Planning Commission Meeting

March 8, 2022 6:00 PM

**DEPARTMENT OF PLANNING AND ZONING
PLANNER'S REPORT**

DATE: March 3, 2022
 TO: Adrienne Senter
 FROM: Lynn Patterson
 RE: **Site Plan Review – POD B, College Avenue, Revised**

D.R. HORTON	HAPEVILLE TOWN HOMES POD B	SITE DEVELOPMENT PLANS	LANDSCAPE PLAN
-------------	----------------------------	------------------------	----------------

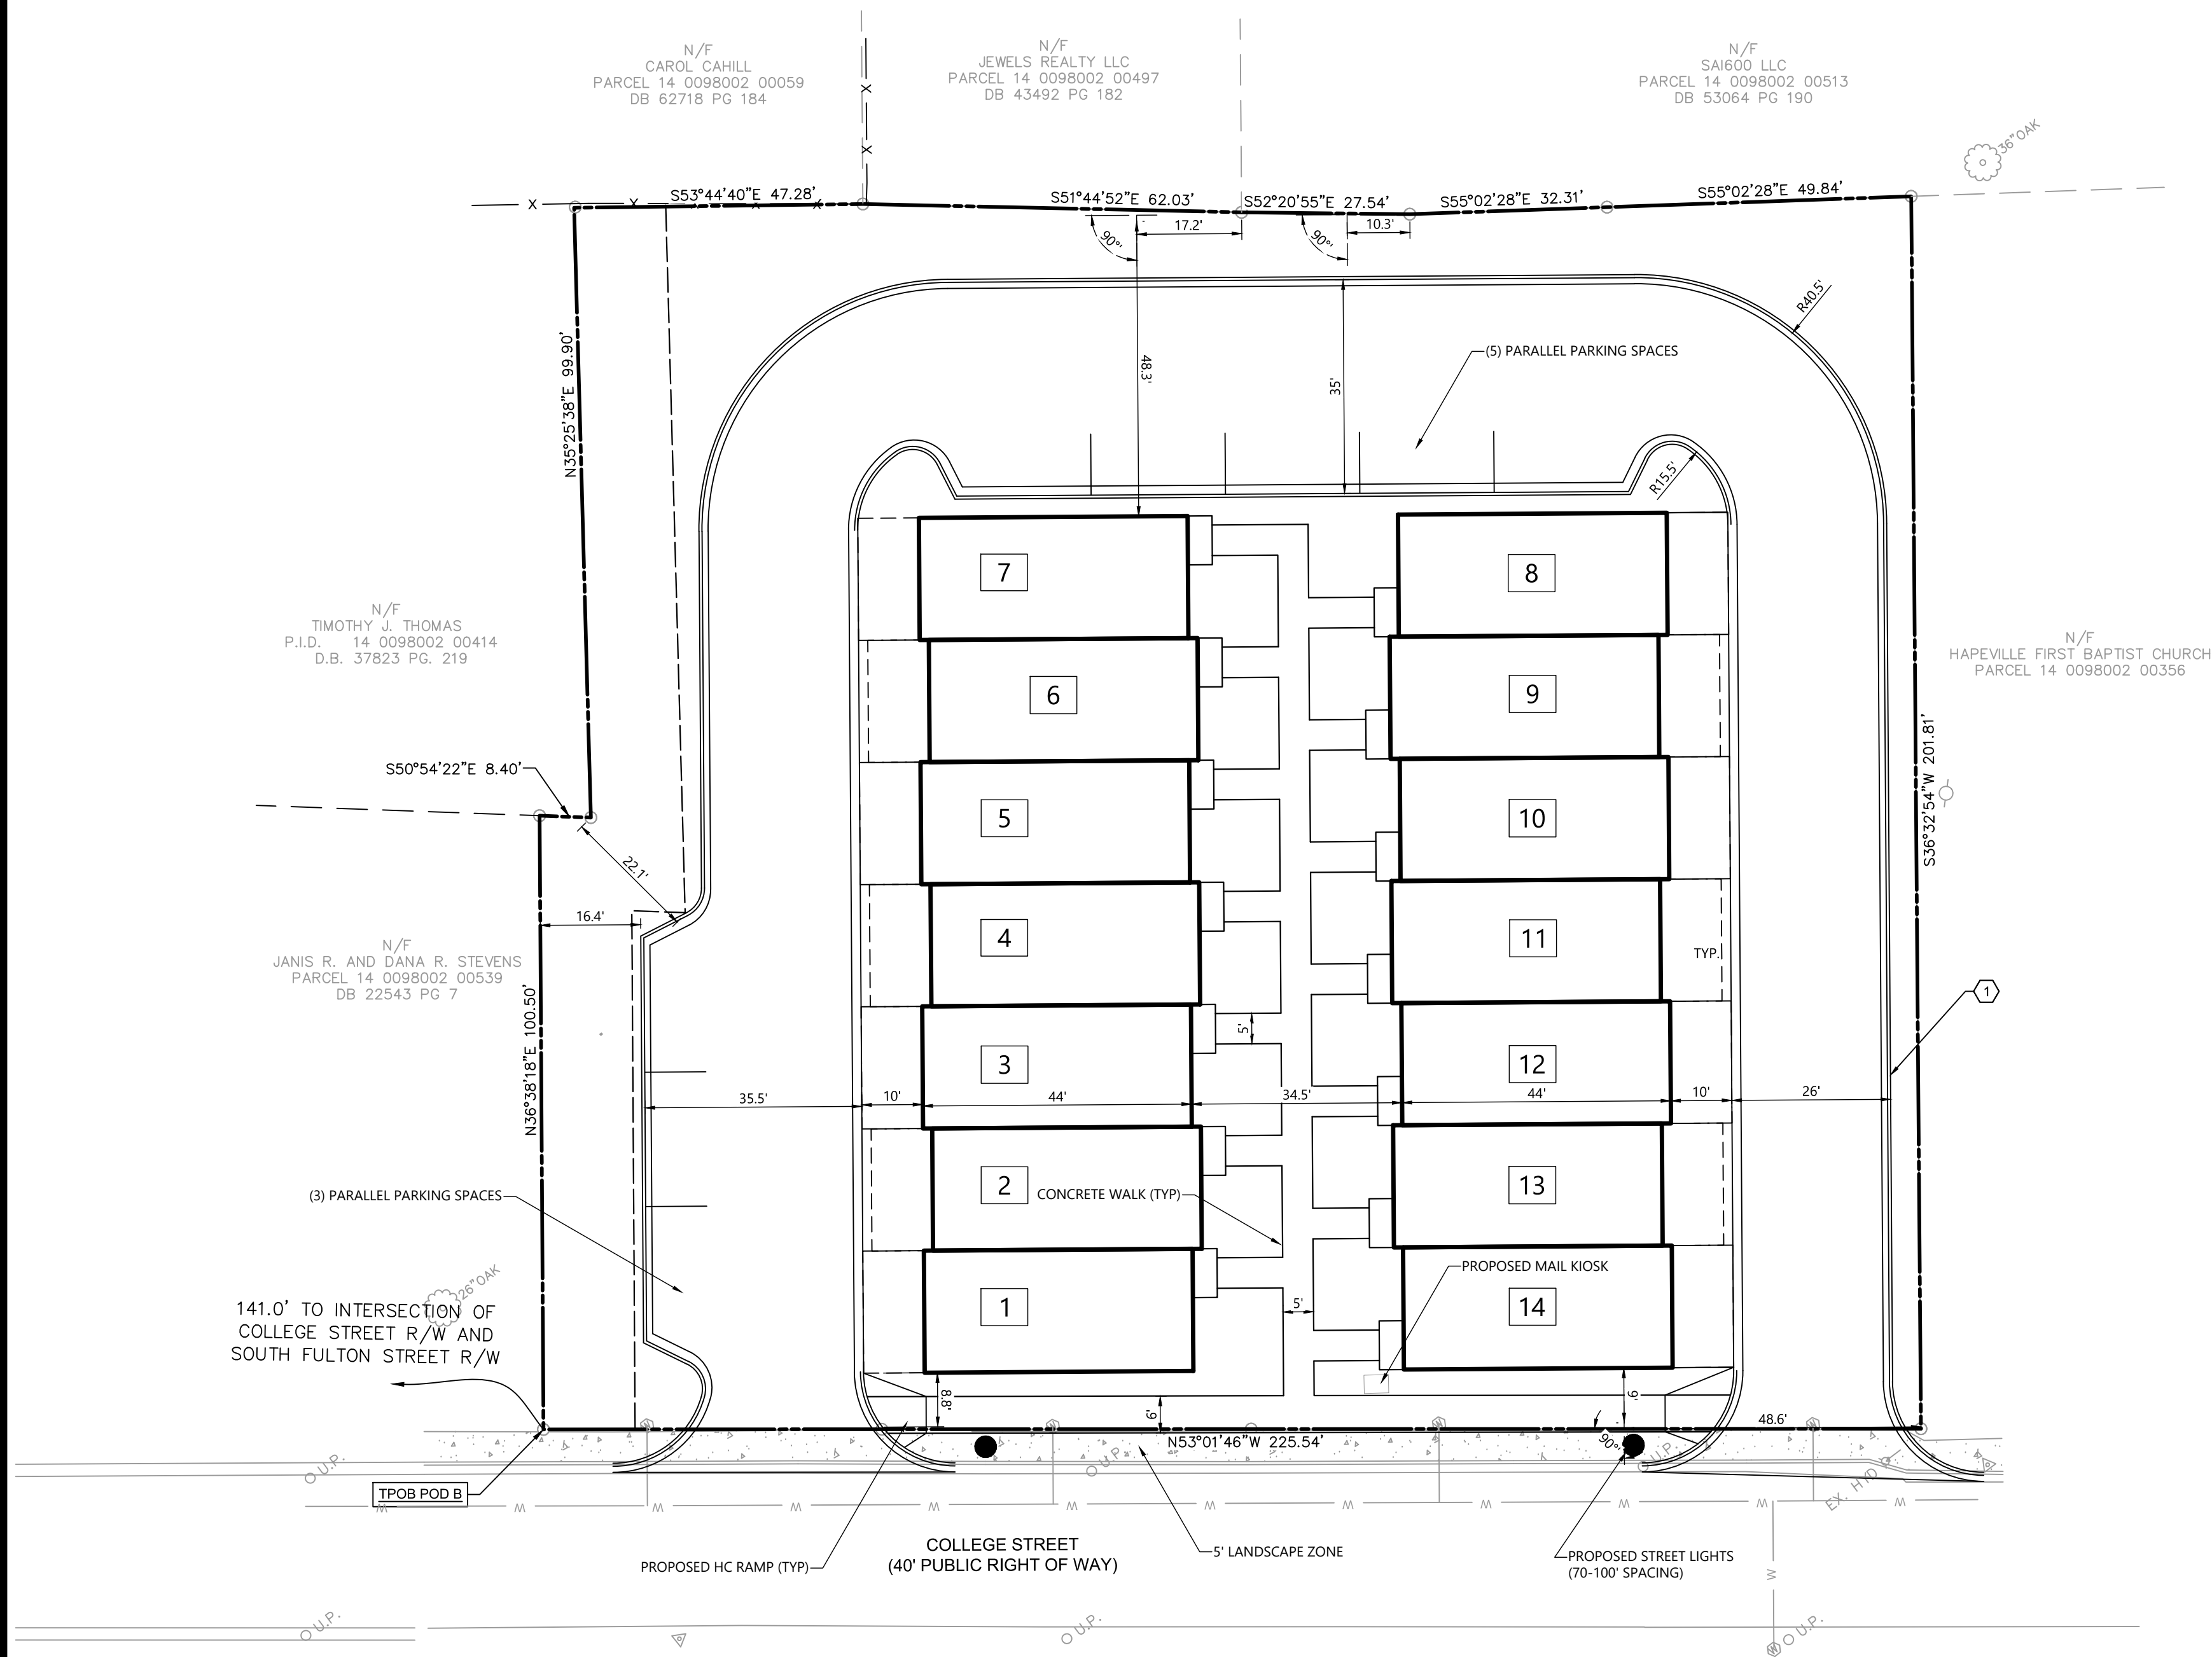
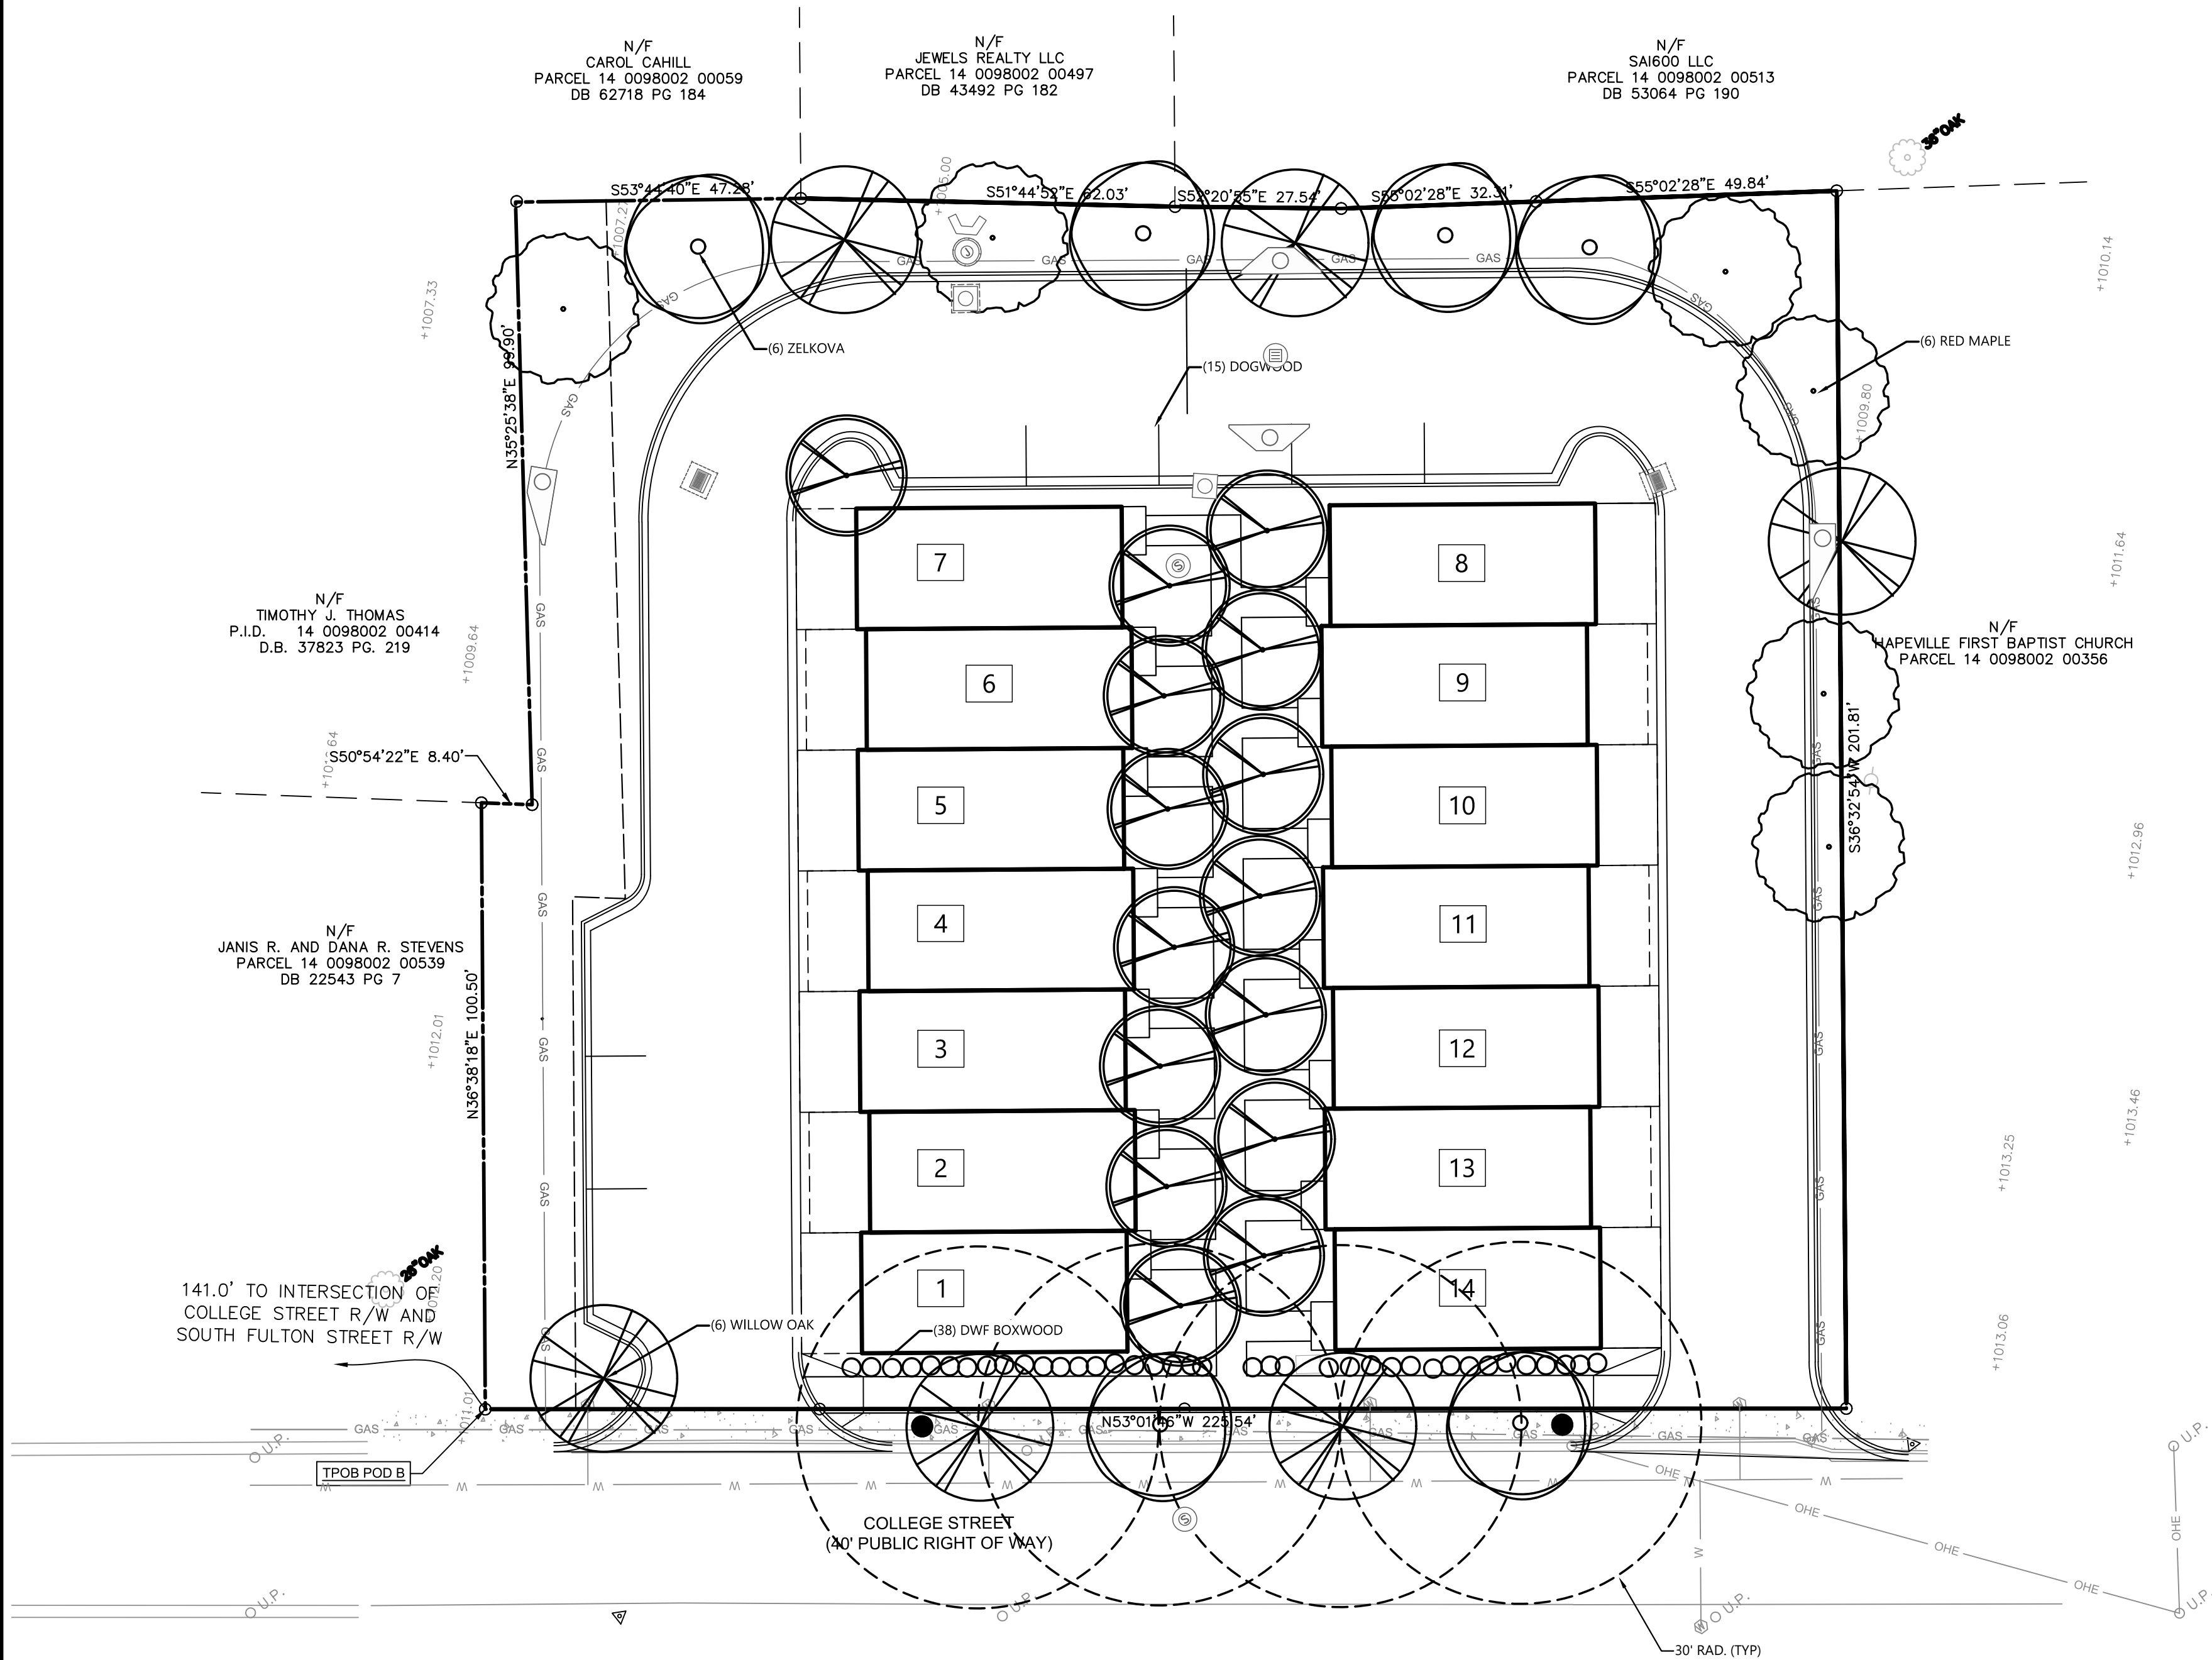
Trees have been provided and Arborist will review. No detail is available regarding a continuous wall, fence, hedge or retaining wall.

1. Provide impervious surface detail and total.
2. Provide detail for required continuous wall, fence, hedge or retaining wall.
3. Provide detail for required landscape area.

4. Provide required buffer between single family attached and single family detached (west of project).
5. Provide intervening driveway materials detail.
6. Provide heights for townhomes.
7. Provide location and parking for mail kiosk.
8. Address any outstanding issues with Tree Conservation Ordinance as per City Arborist report.
9. Address any outstanding issues on the Engineer's Report.
